## REQUEST FOR A SEALED SOURCE OR DEVICE EVALUATION

**Re: NR-1081-S-101-S**

This letter is to advise you that we are making a change in the construction of our Palladium-103 seed as described in the letter to the NRC dated July 29, 2001 which is listed in the References section of "Registry of Radioactive Sealed Sources and Devices Safety Evaluation of Sealed Source" No. NR-1081-S-101-S.

# AMMENDMENT and CORRECTION TO APPLICATION FOR REGISTRATION OF BRACHYTHERAPY SEED FOR MEDICAL USE

**Construction of ProstaSeed I-125**

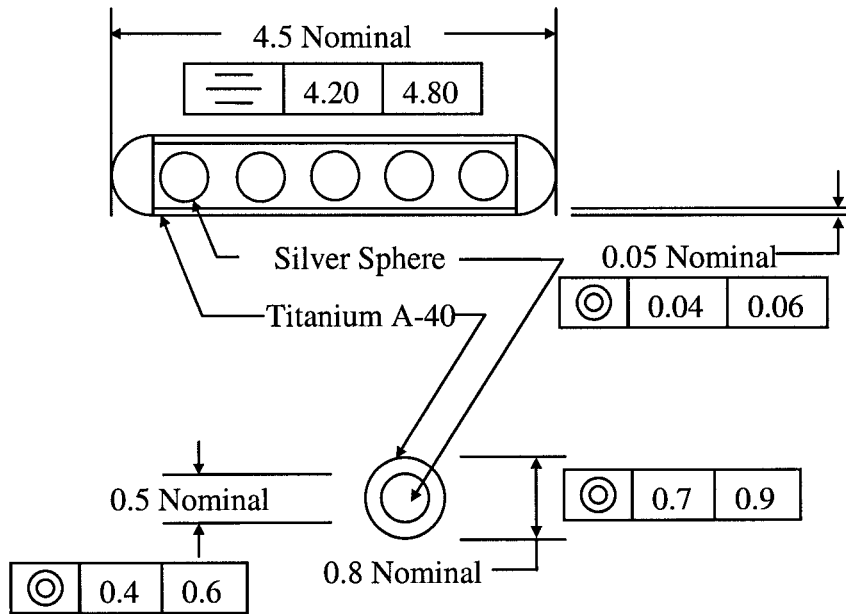
We are also clarifying the same statement for the I-125 seed. While all silver spheres used in the I-125 seed will remain radioactive, the seed may contain three – five spheres as stated in the Registration Certificate No. NR-1081-S-101-S dated December 1, 1999.

Both models contain **three to five** silver spheres. The Model I-125 SH contains a maximum activity of 150 mCi (5.55 GBq) and the Model I-125 SL contains a maximum activity of 1 mCi (37 MBq). The two models differ only in total radioactivity contained.

1. All dimensions in millimeters
2. Not drawn to scale
3. The seed may contain 3 to 5 silver spheres
4. All five silver spheres are radiolabeled with Iodine - 125

**Construction of ProstaSeed Pd-103**

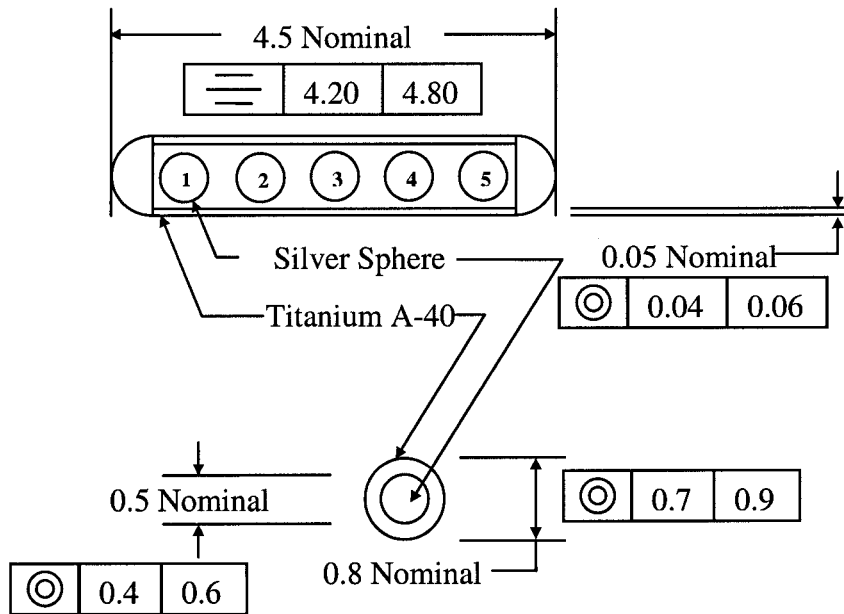
The July 29, 2001 letter states that "Both I-125 and Pd-103 models contain five silver spheres. All silver spheres are coated with radioactivity, i.e. we do not manufacture the sources with inert spheres for spacing purposes." Prior to the market launch of the Pd-103 seed it was determined that therapeutic effectiveness of the seed could be improved by reducing the number of radioactive spheres in the seed to two, and placing them in the sealed Titanium shell in a 1 HOT, 3 COLD, 1 HOT configuration. This change does not adversely impact the safety or effectiveness of the seed as described in this referenced Registration Certificate.

The Model Pd-103 SH and Pd-103 SL seeds contain palladium-103 on the solid silver spheres. Physical dimensions of both the silver spheres and titanium casting if the Model Pd-103 SH and Pd-103 SL seeds are identical to those of the iodine seeds as described above. **The titanium tubing is welded on one end, inverted, five spheres are added in a 1 hot – 3 cold – 1 hot configuration, and the remaining end is welded closed (See attachment 2).** The Model Pd-103 SH contains a maximum activity of 185 MBq (5 mCi) and the Model Pd-103 SL contains a maximum activity of 111 MBq (3.00 mCi). The two models differ only in total radioactivity contained.

1. All dimensions in millimeters
2. Not drawn to scale
3. The seed will contain 5 silver spheres
4. Silver spheres 1 and 5 are radiolabeled with Pd-103
5. Silver spheres 2, 3 and 4 are non-radiolabeled (inert) used for spacing
